October 12, 2012

RE: Traffic Review for Parke Lane at Newburgh, Stewart Avenue, Town of Newburgh, NY; Town Project No. 2012-13, CM Project No. 112-164.

NYR9-3

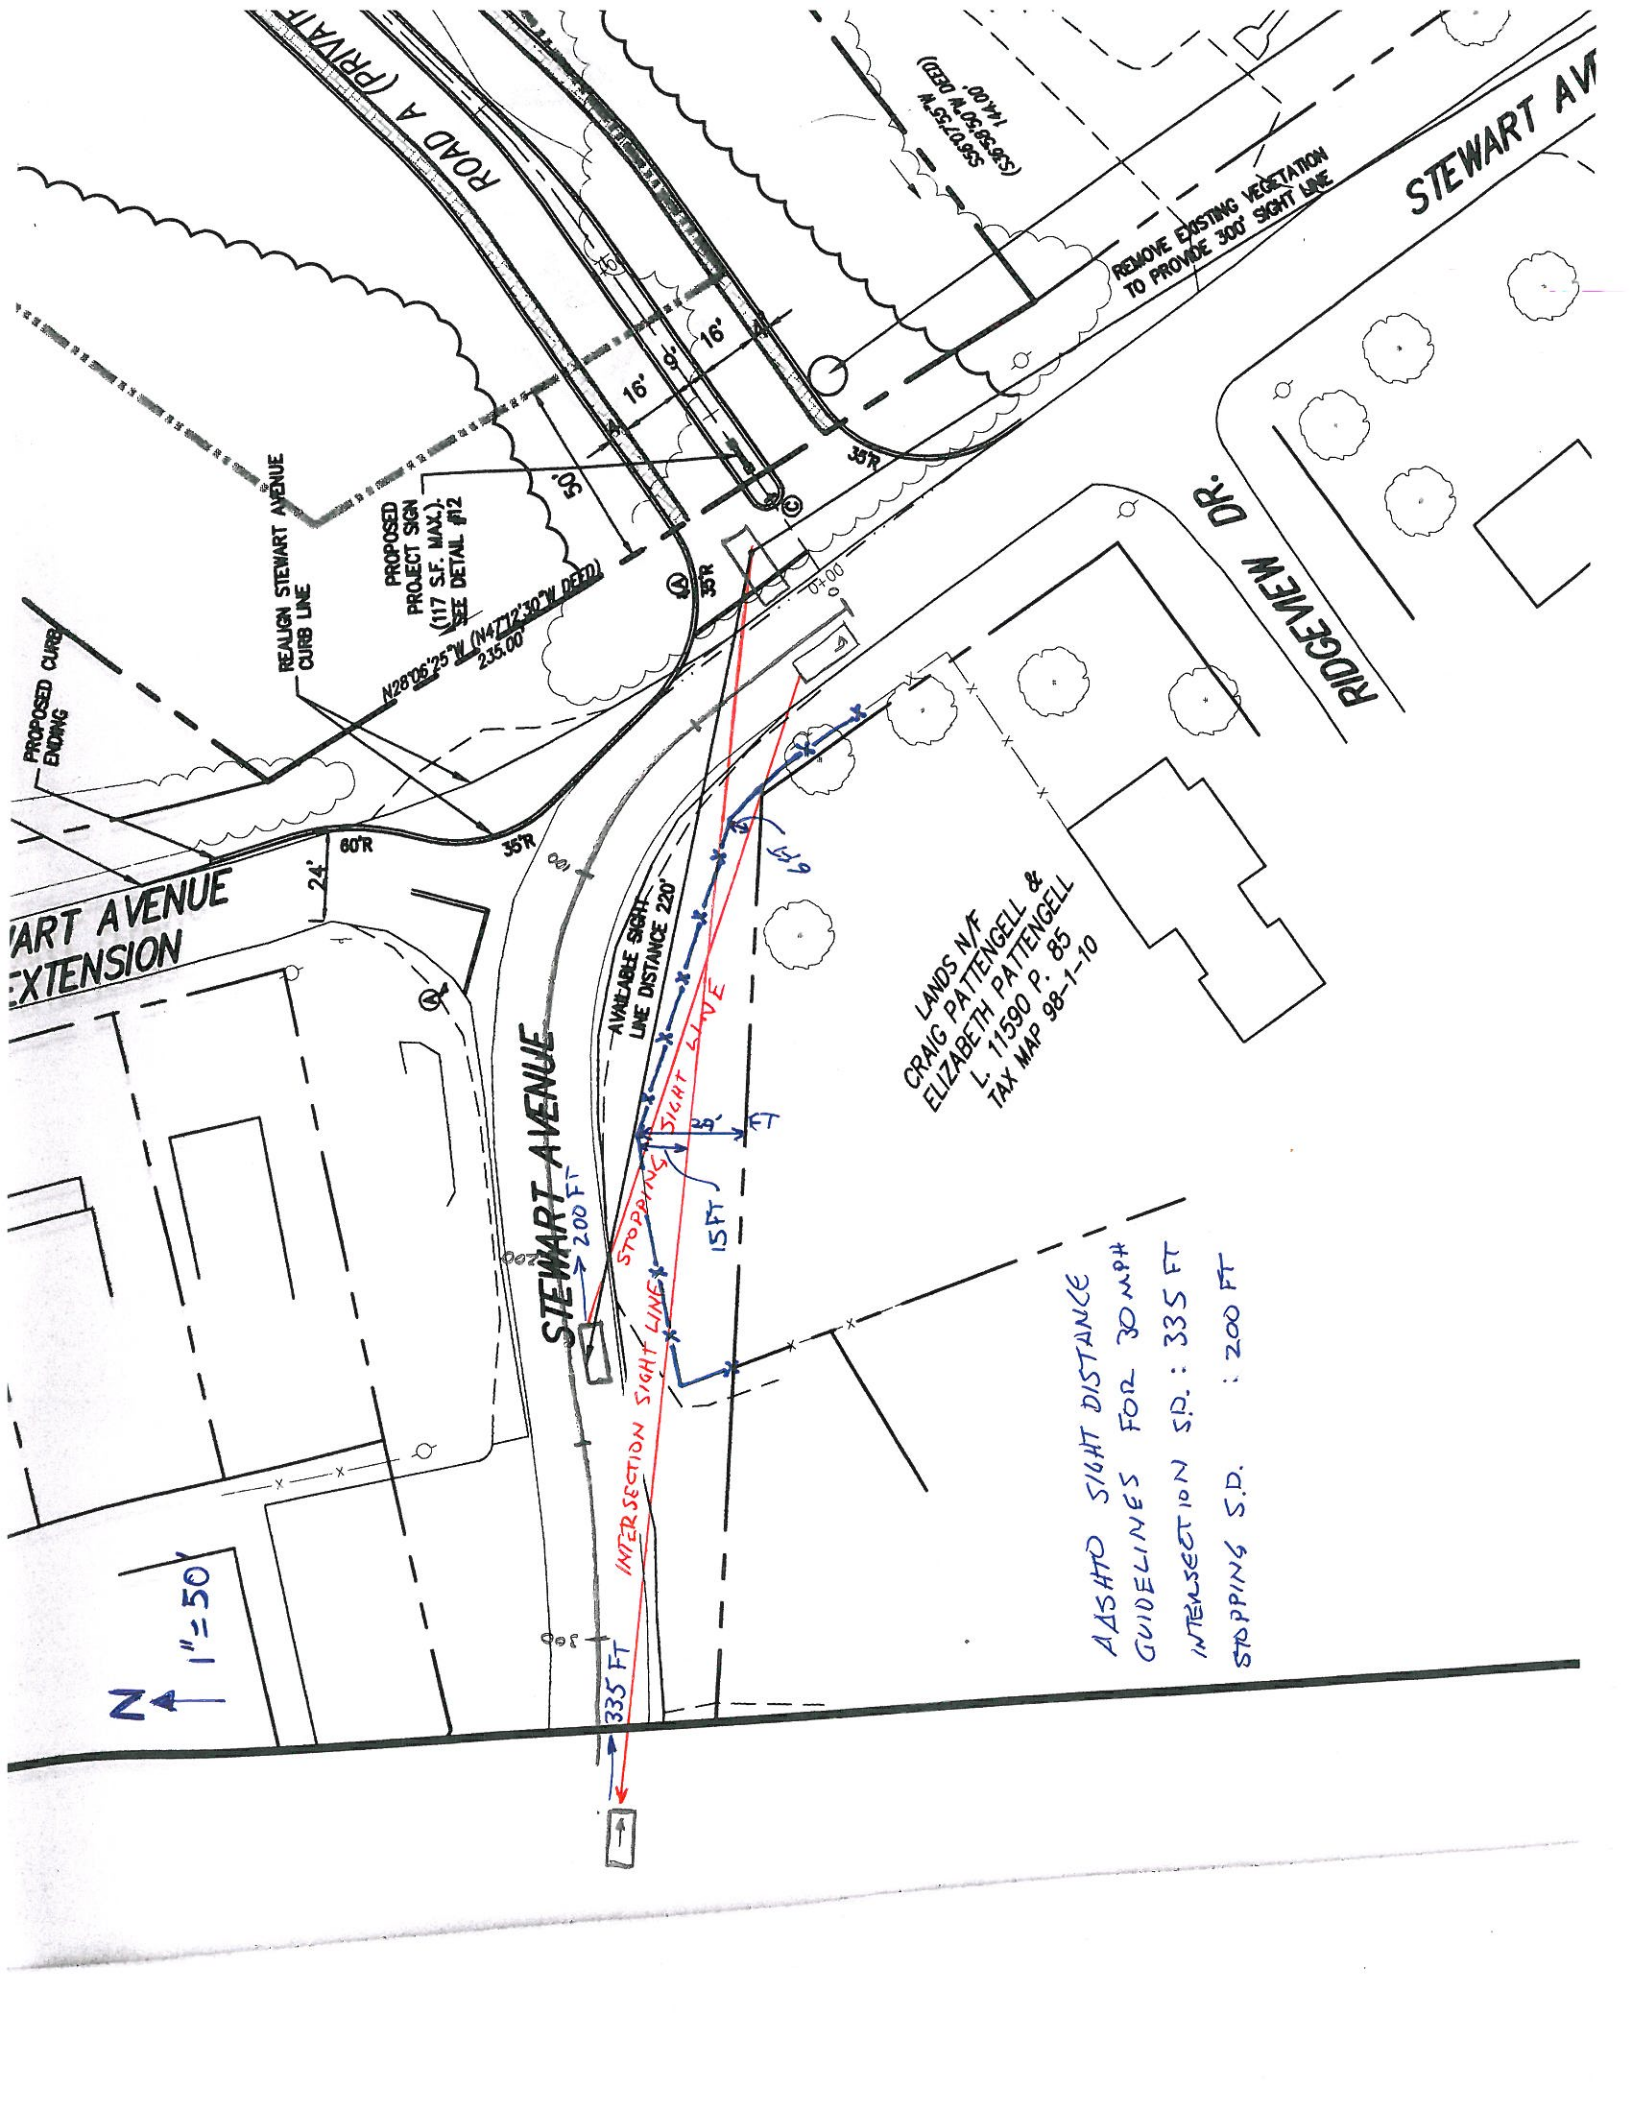
2. It is recommended that the Town Engineer and Highway Superintendent review the site driveway location and provide any additional recommendations.
3. On the matter of sight distance, the AASHTO recommended guideline for sight distance on a 30 mph road is 335 feet for intersection sight distance (a driver pulling out of the side street) and 200 feet for stopping sight distance (a driver stopping behind an entering vehicle). The attached sketch illustrates the sight lines needed to meet these distances. As shown, stopping sight distance would require the Pattengell fence to be moved approximately 6 feet out of the Town ROW, while the intersection sight distance would require approximately 15 feet.
